# ADDENDUM No. 1

## RFP No. 24-10

### 2024 Miscellaneous Utilities Project

**CITY OF ANN ARBOR - PUBLIC SERVICES - ENGINEERING**  
**ANN ARBOR RAILROAD / BOARDWALK CULVERT IMPROVEMENTS PROJECT**

# EXHIBIT

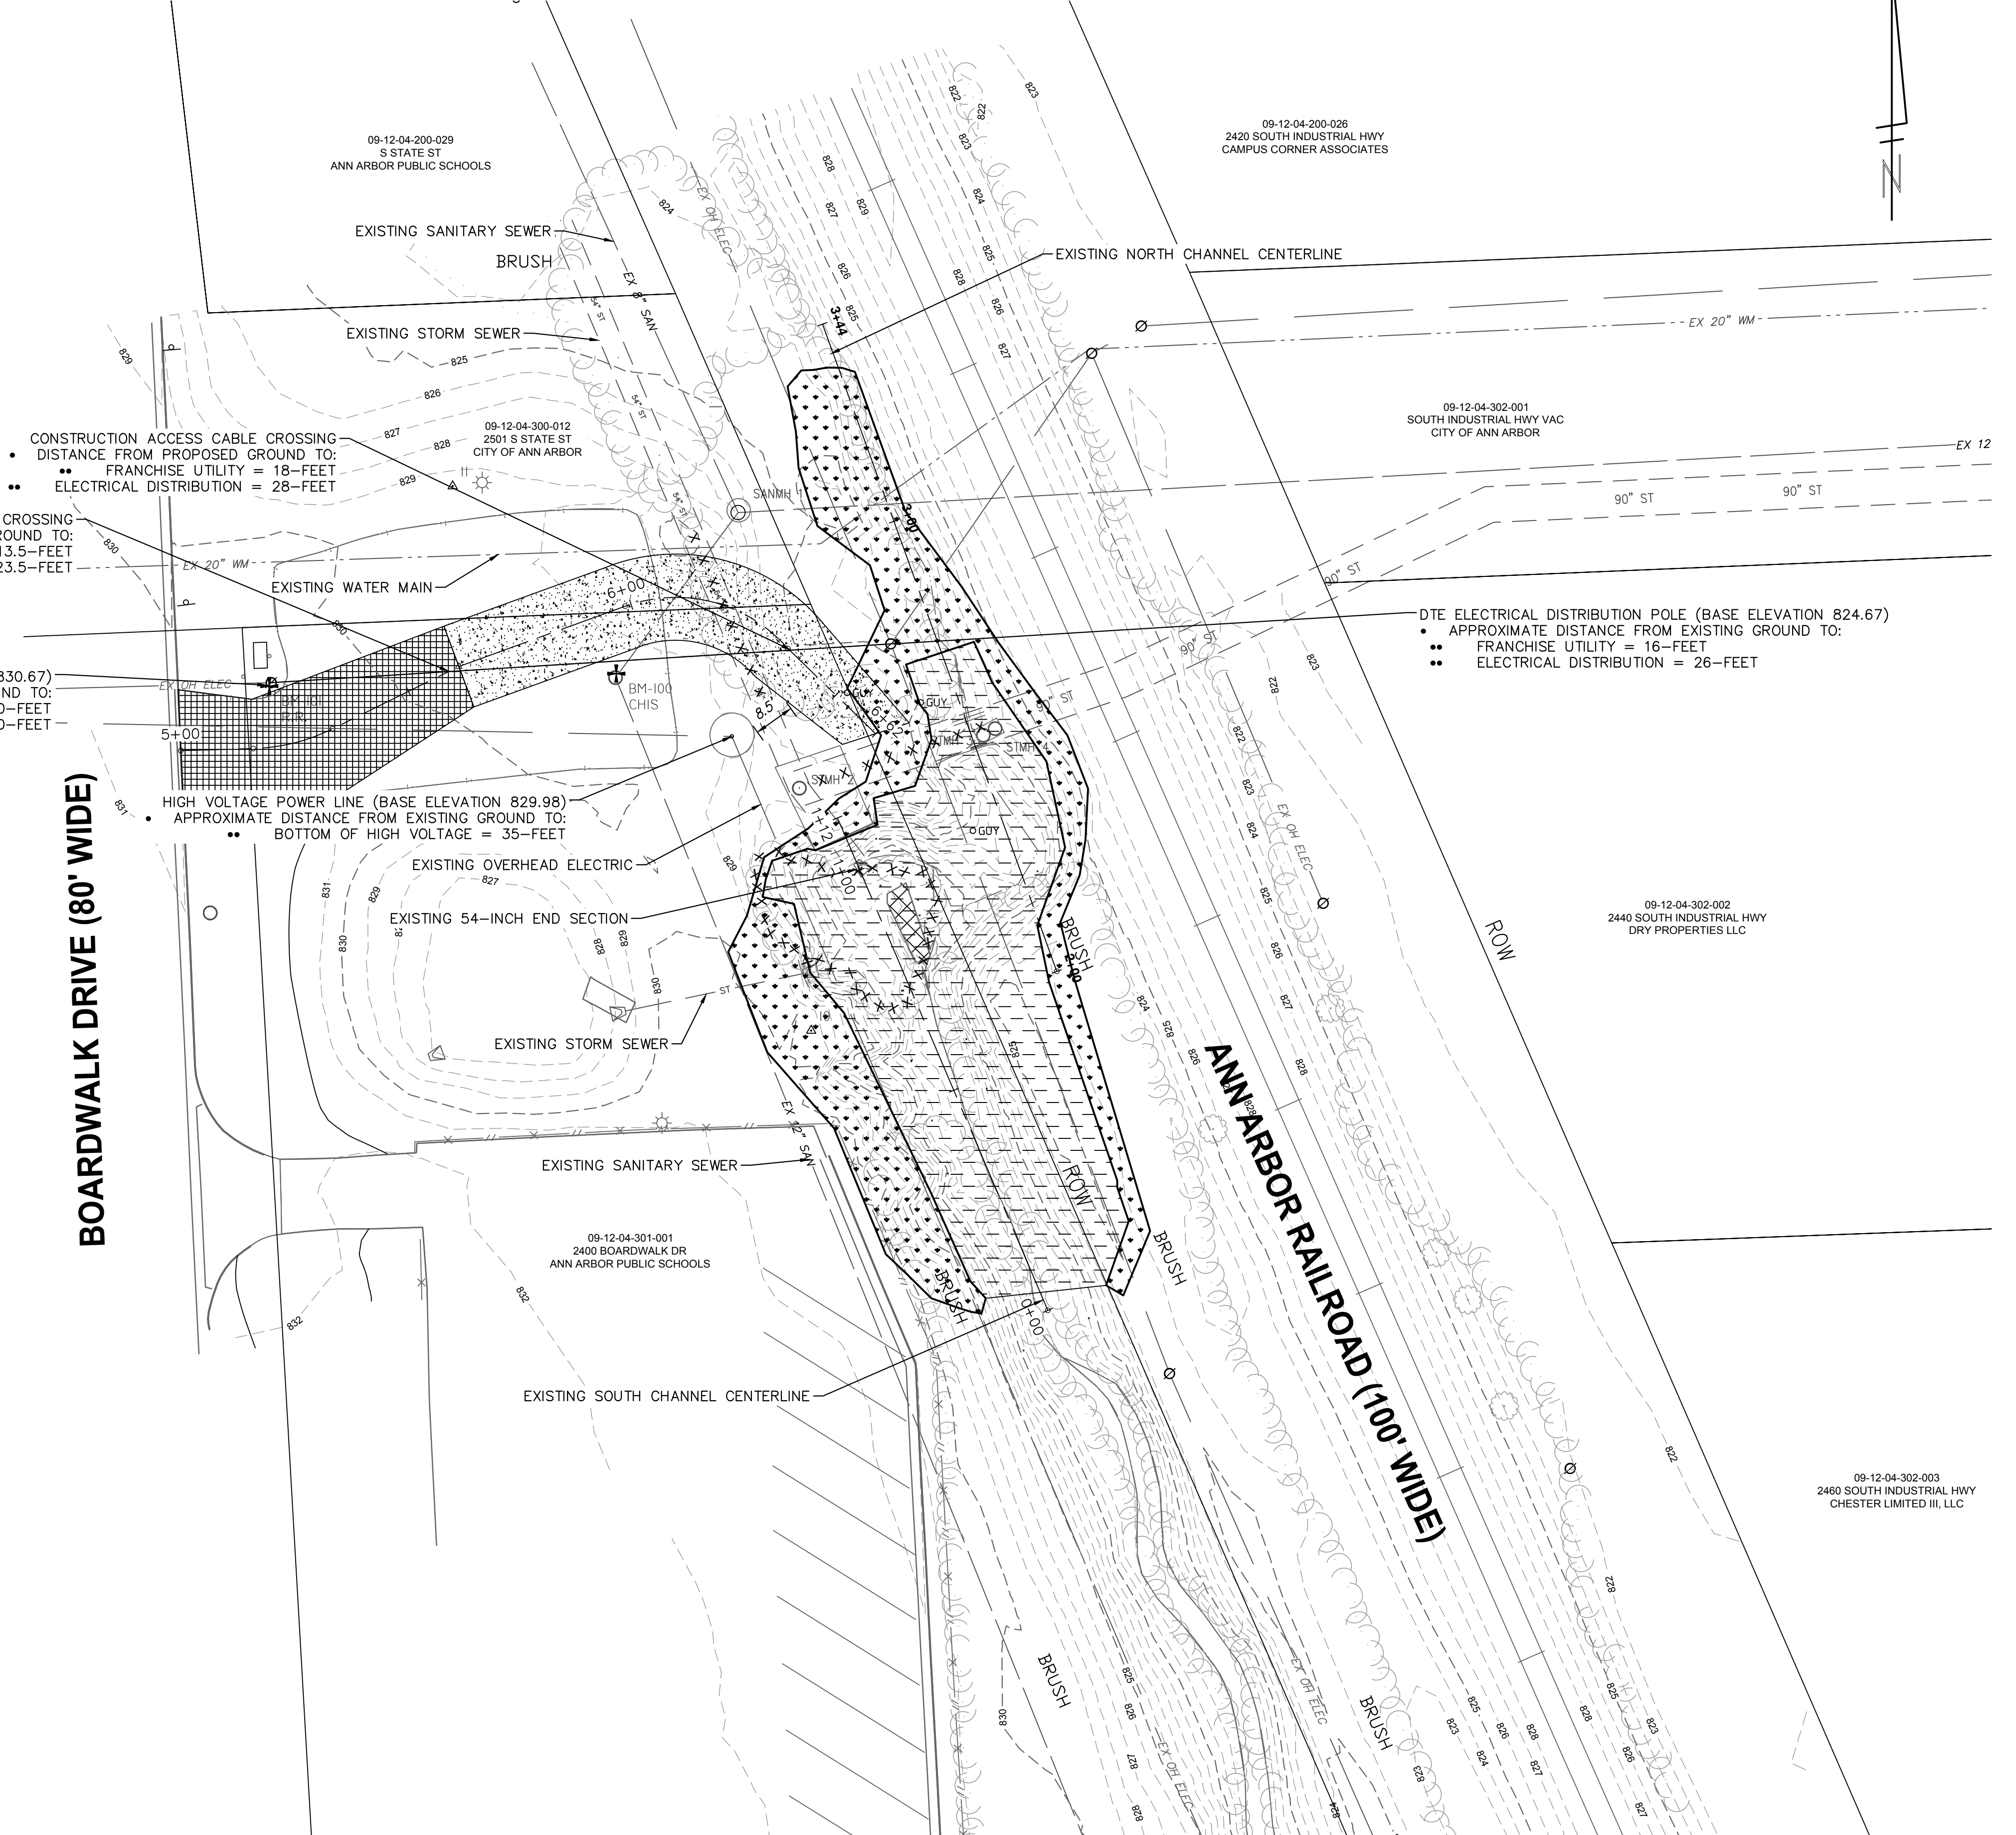
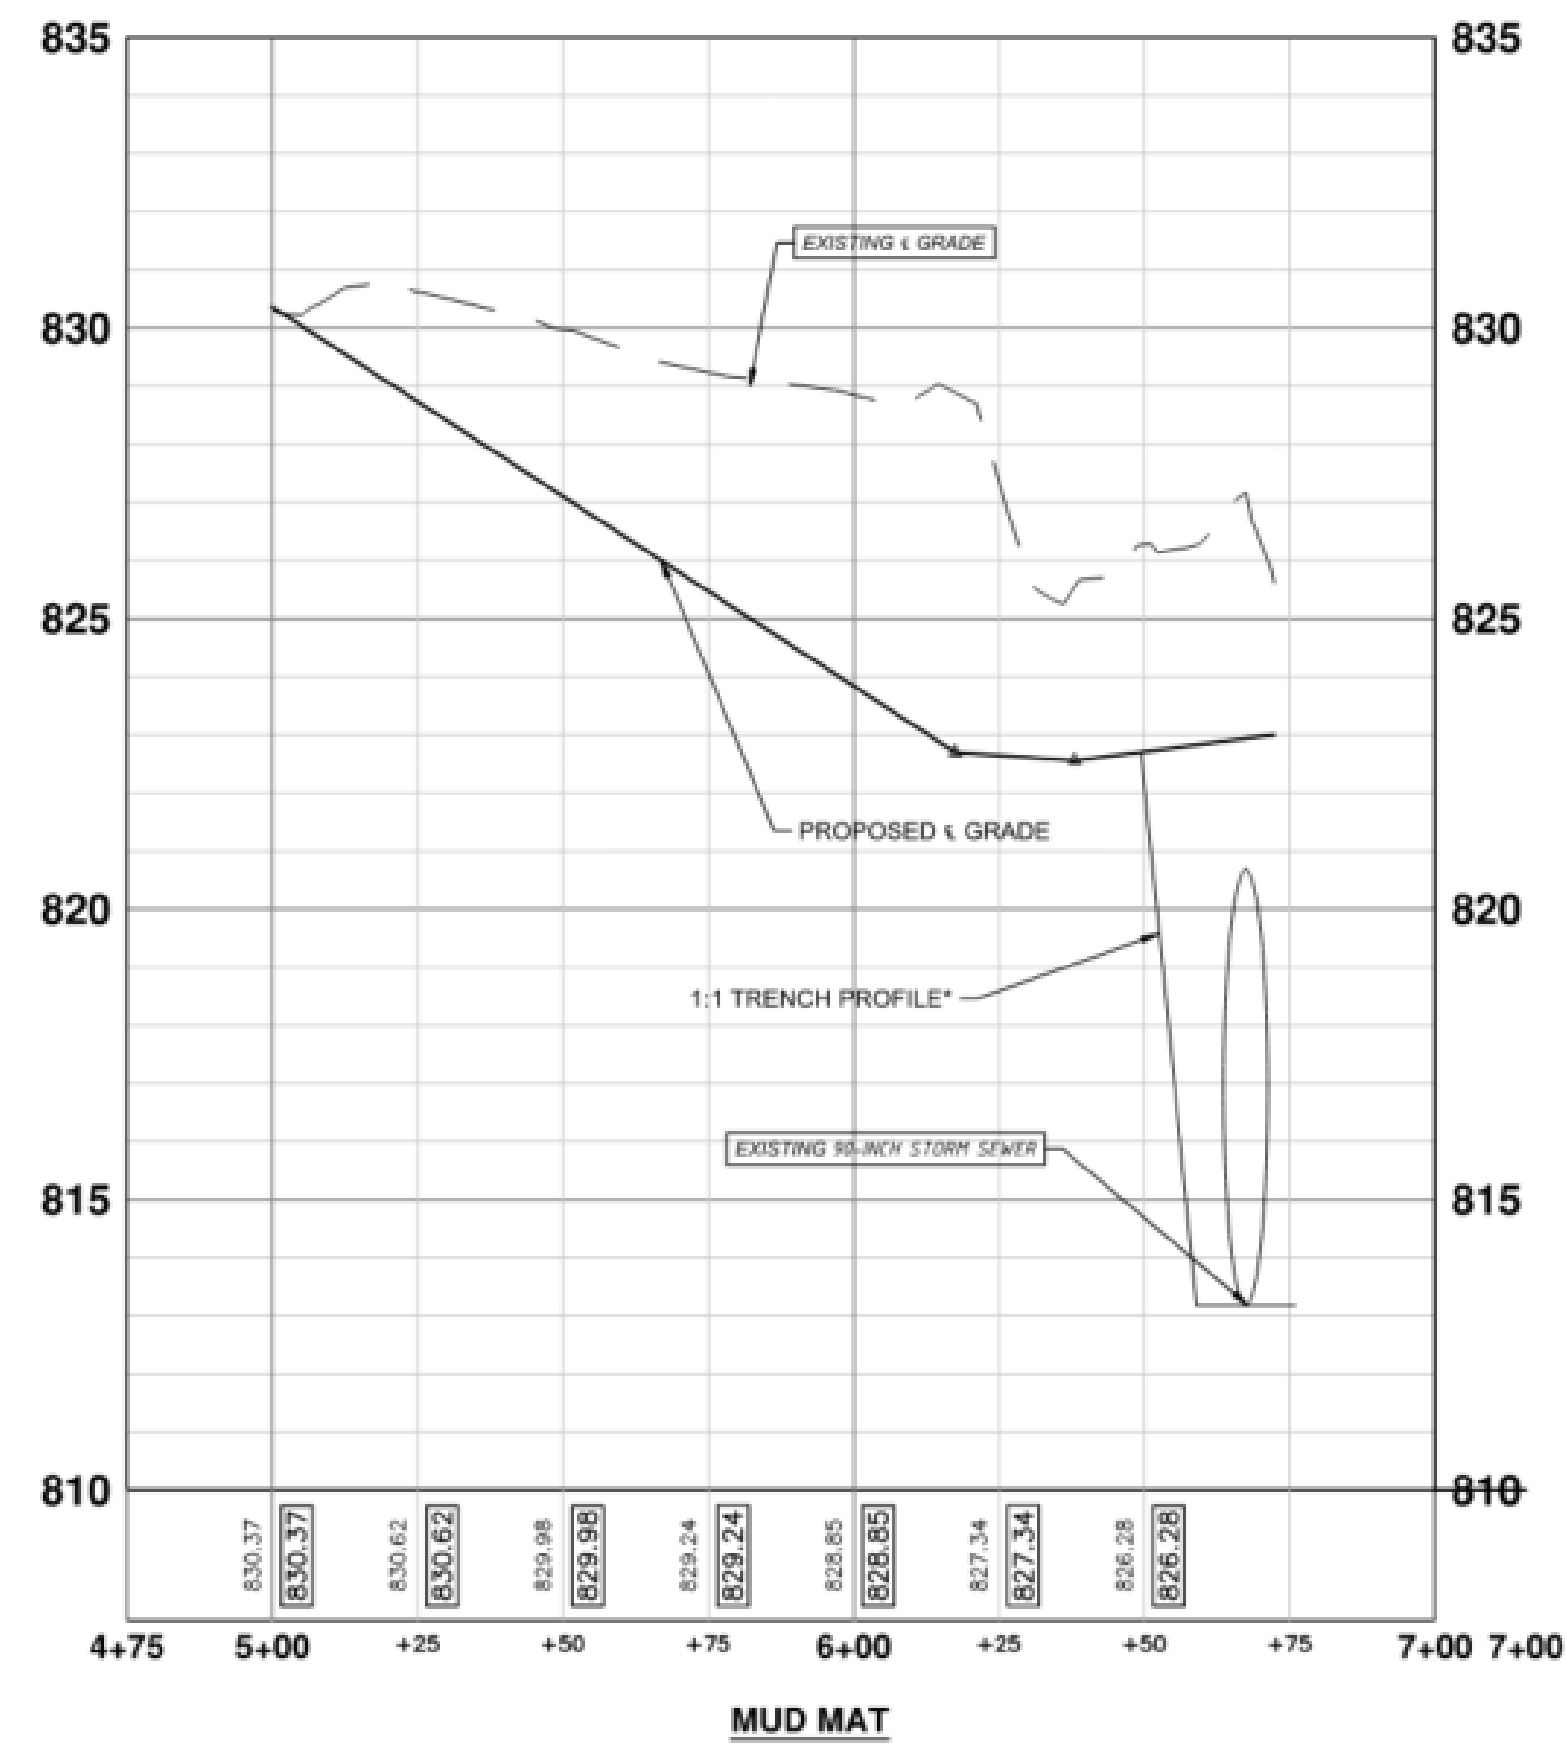
Question 15: What is the voltage of the overhead lines near the railroad culvert and what is the minimum clearance for them?

Answer 15: Voltages and clearances are shown in the Exhibit that is included in this addendum.

THE CITY HAS NOT BEEN ABLE TO CONFIRM THE VOLTAGE OF THE HIGH TENSION POWER LINES. WE SUSPECT THAT THE VOLTAGE IS UNDER 350 KV AND WOULD BE SUBJECT TO THE MINIMUM MIOSHA 20-FOOT VERTICAL CLEARANCE.

00	2/21/24	ENG	CEC
REV. NO.	DATE	DRAWN BY	CHECKED BY
<b>STANDARD STORM MANHOLE (SEPARATE BASE)</b>			
DR. ENG	CH. ENG	DRAWING NO.	
SCALE N.T.S.	DATE 12/8/2023	<b>SD-ST-1A</b>

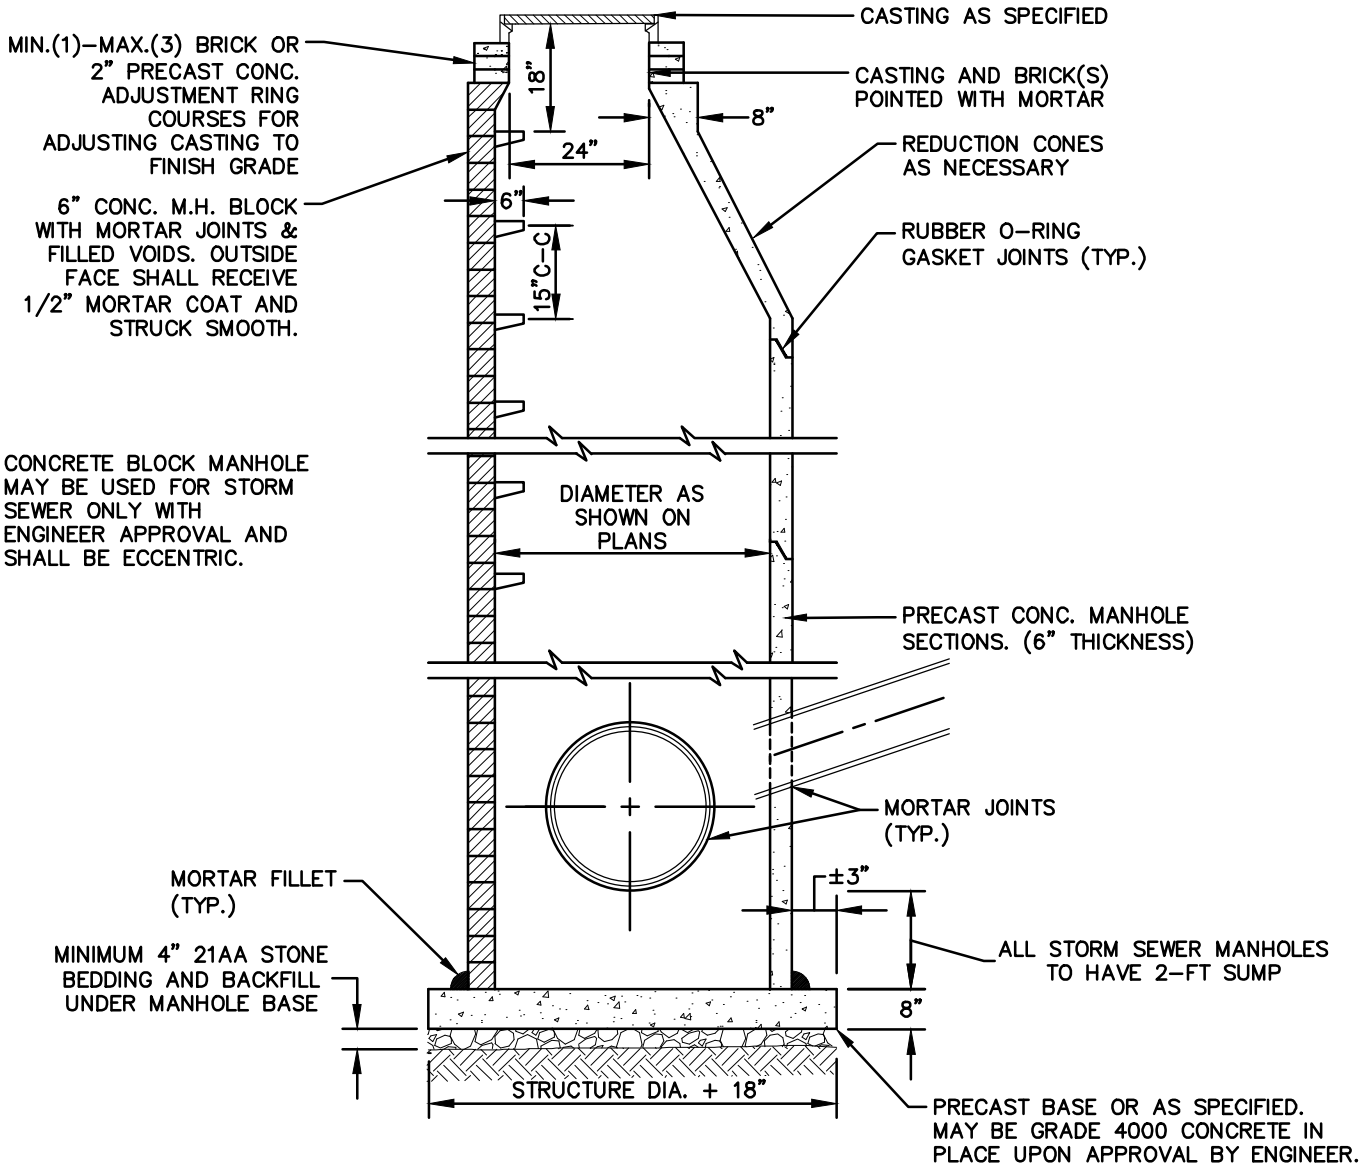
<b>Section/Page(s)</b>	<b>Change</b>
<u>New Content</u> Add#1-6 – 8	Pre-Proposal Meeting Minutes
Exhibit	Overhead Line Clearances
Table 1 – Updated Orkney/Culver Fittings	22.5-degree bends that are changed to 45-degree bends
SD-ST-1A Rev. No. 00 – Standard Storm Manhole (Separate Base) Detail	Rubber boot connections and testing sleeve removed

Question 10: Do the storm manholes require booted connections?

Answer 10: No, the storm manhole detail (SD-ST-1A) was updated and is included in this addendum.
